ADDENDUM NO. 3

DATE OF ISSUANCE:	April 25, 2024
PROJECT:	2024 Addition and Renovations North Harrison Elementary School 1115 W. Whiskey Run Road Ramsey, IN 47166
OWNER:	North Harrison Community Schools
ARCHITECT'S PROJECT NO.:	23-228.001
ORIGINAL BID ISSUE DATE:	April 03, 2024

UE100

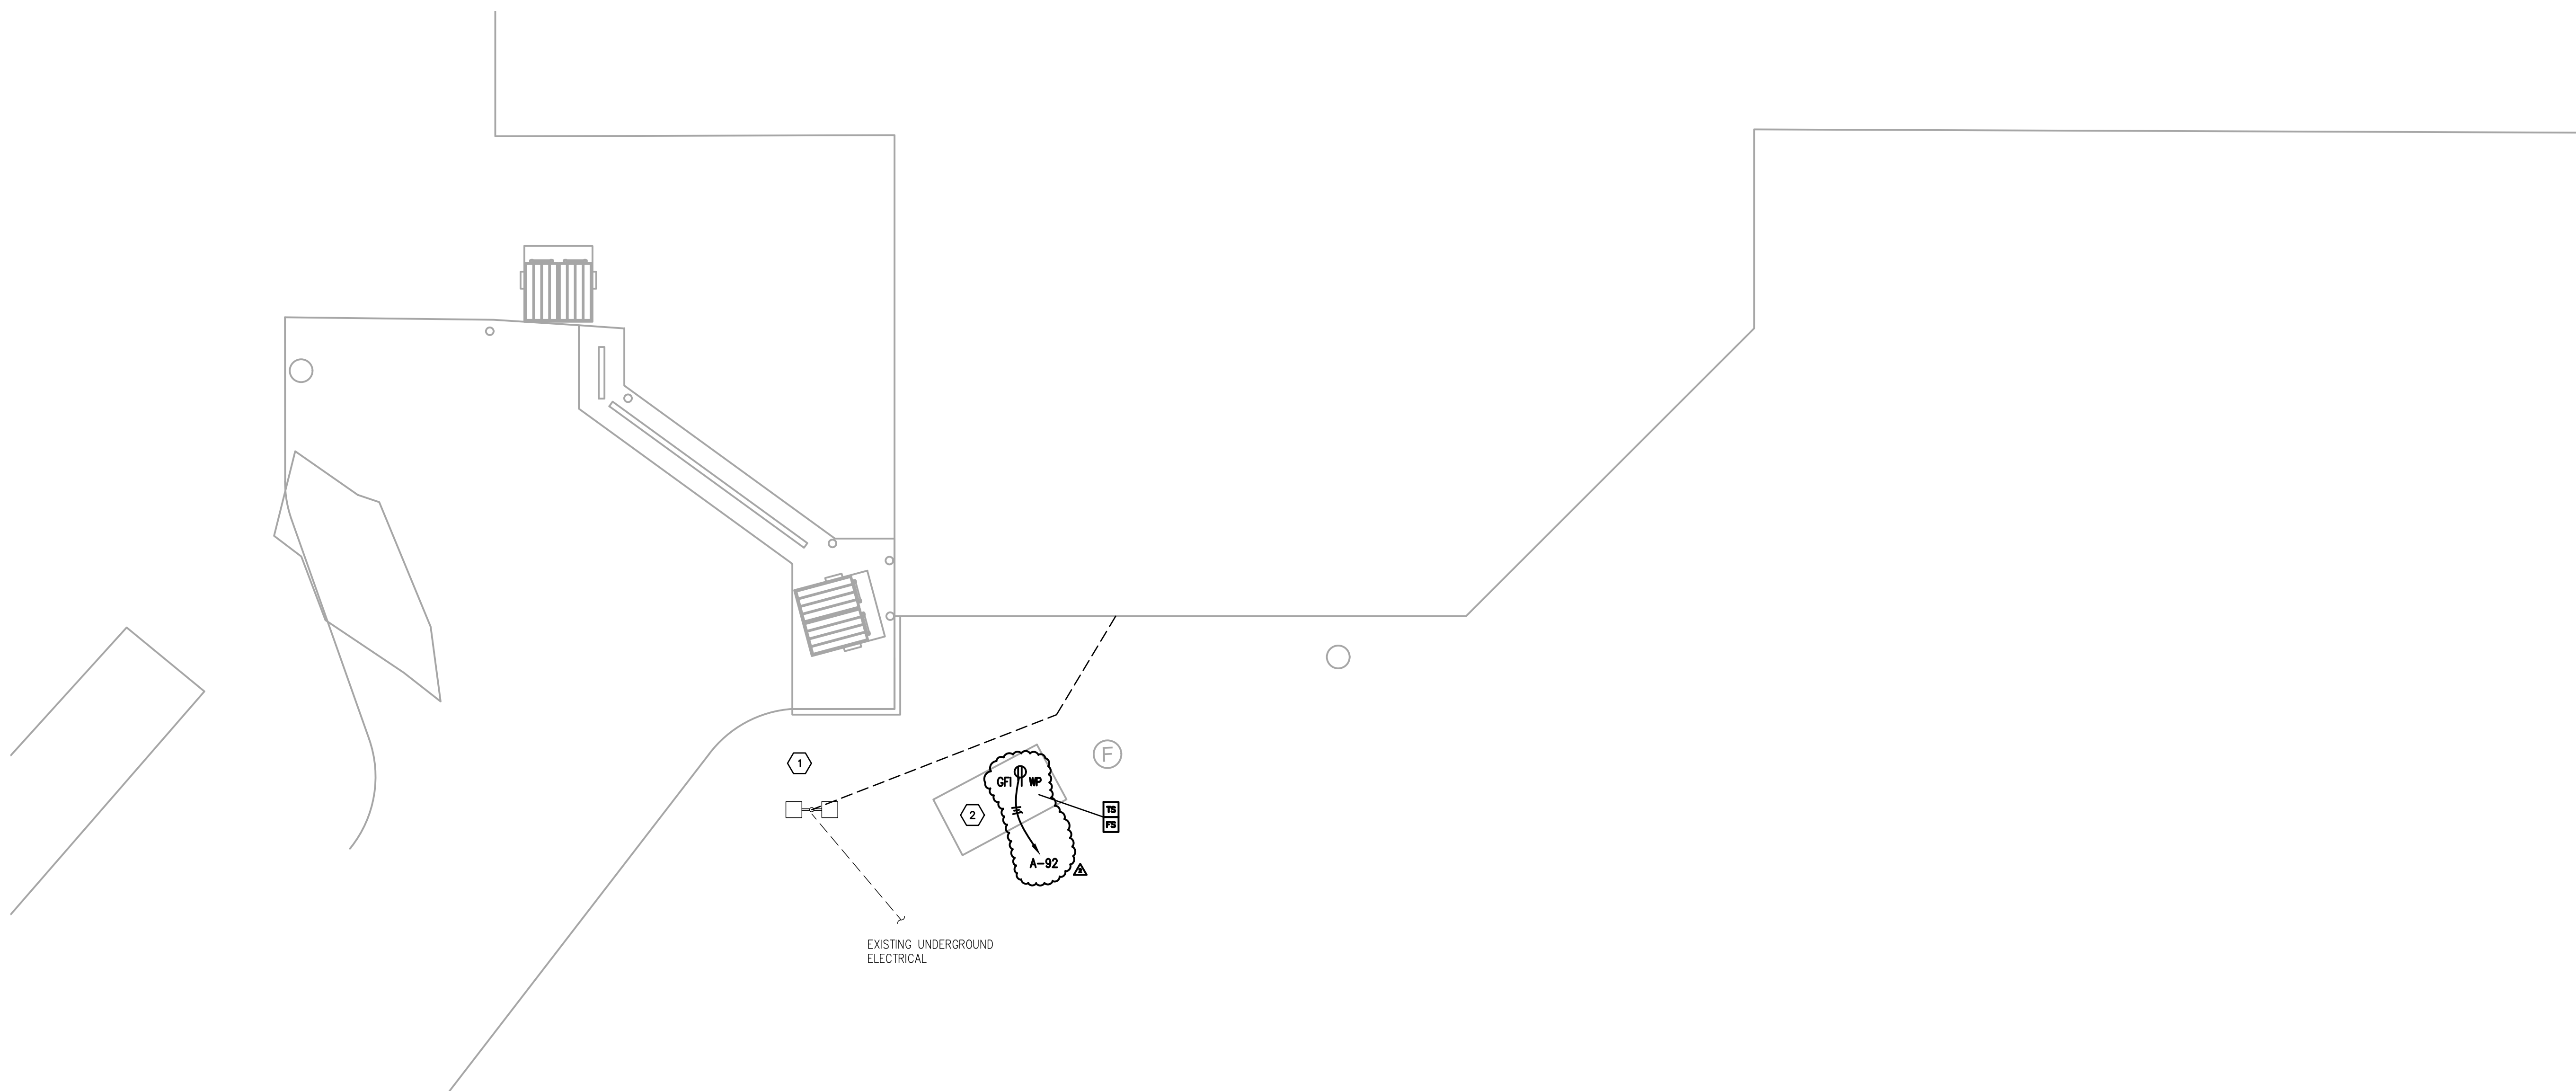
ADD-3 Item No. D-11 - Fire Vault Connections and View Scales

Refer to Sheet(s): **UE100**

- Updated tagnote #2 to be as follows: "Provide new tamper and flow switches as shown at new fire vault location. Remove and replace existing fire alarm connections to new vault location and connect new fire alarm devices. Field verify exact conditions prior to construction."
- Fixed incorrect scales for site plan views on sheet from 1/16" – 1'-0" scale to 1/8" – 1'-0" scale.

T101

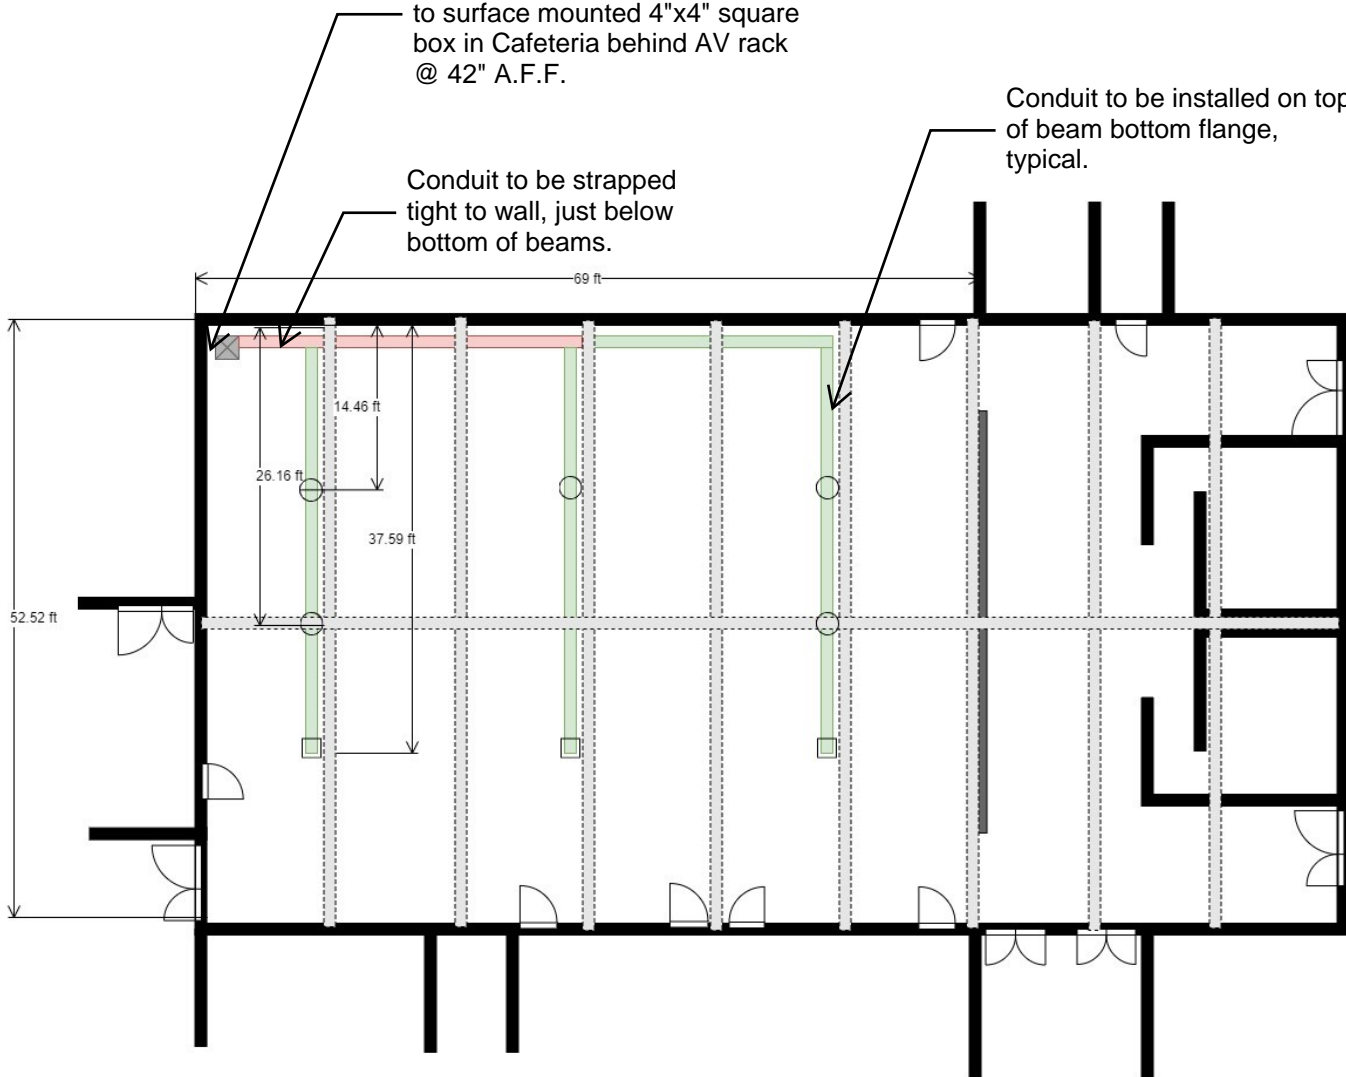
ADD-3 Item No. D-12 - Future Cafeteria Sound System

Refer to Sheet(s): **T101**

Add attached Drawing T101 provided by Owner's separate vendor indicating conduit pathway for Owner's future sound system located in Cafeteria 133 to be installed outside of the scope of this project. Contractor shall include providing and installing all pathway components as indicated within the Base Bid of this project. Conduits to be installed prior to painting within room.
